TITLE OF PROJECT: Shaw Hall – HVAC Upgrades In Dishwasher Room

PROJECT NUMBER: CP25012

ADDENDUM NO: 1

CURB FLASHING
NO SCALE

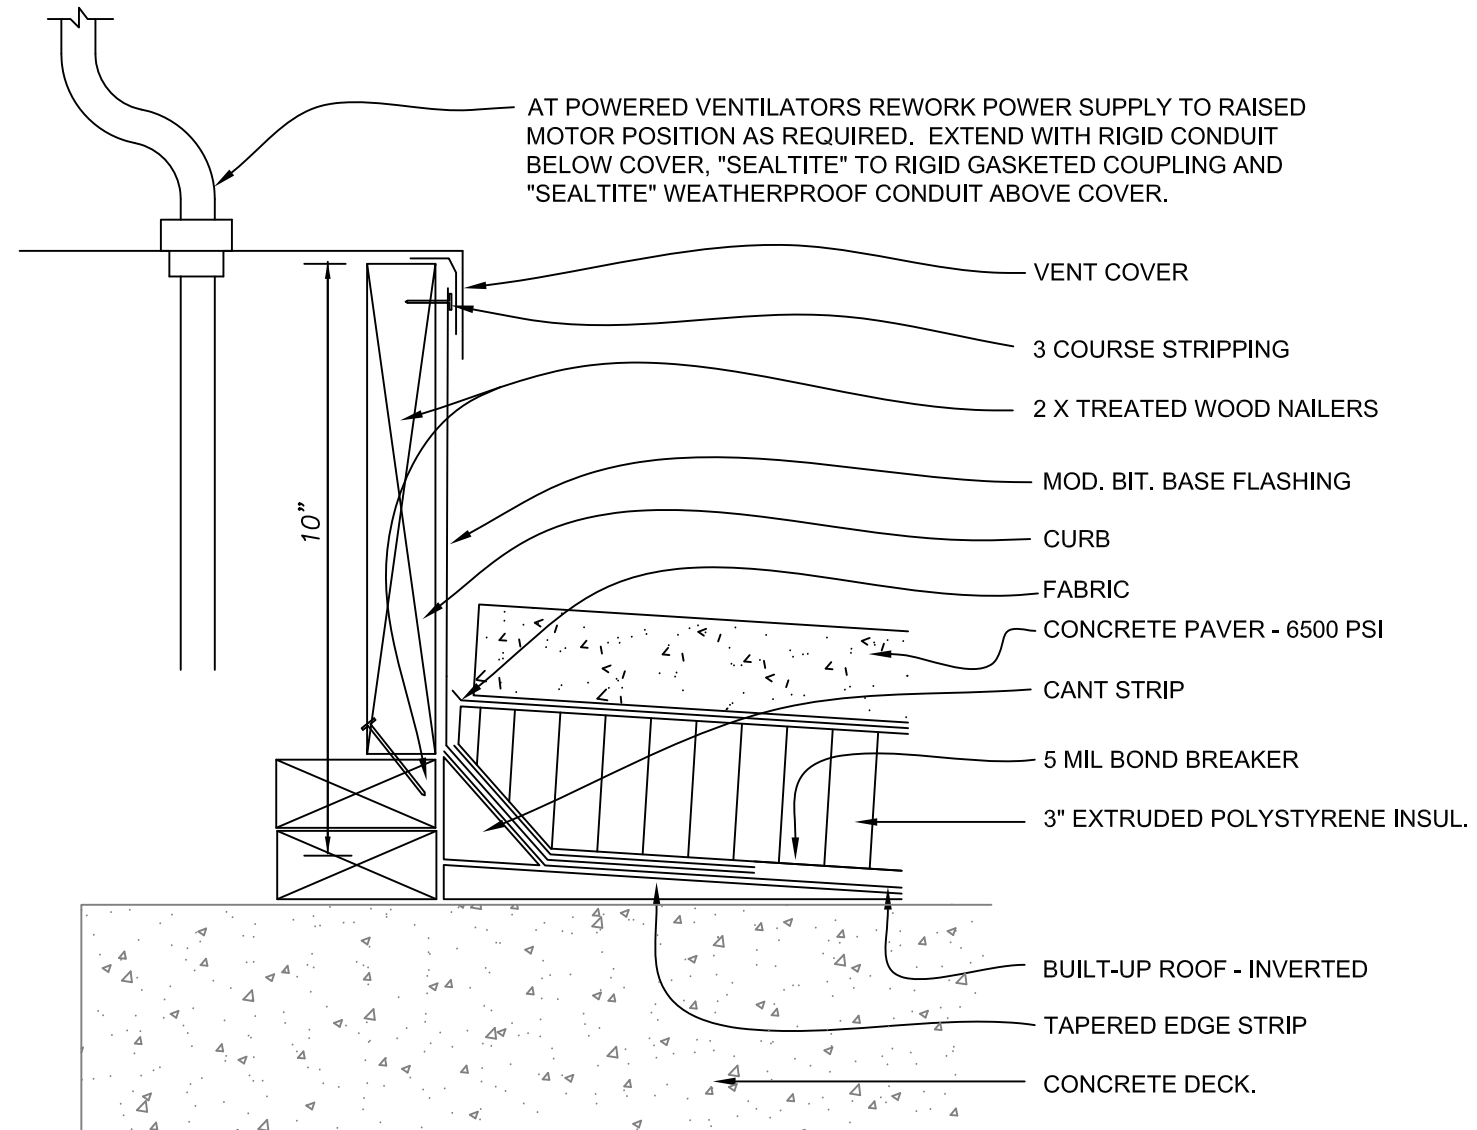
1.	2'x2' concrete pavers – 6500 psi shall be installed around perimeter of EF-1 curb.
----	--
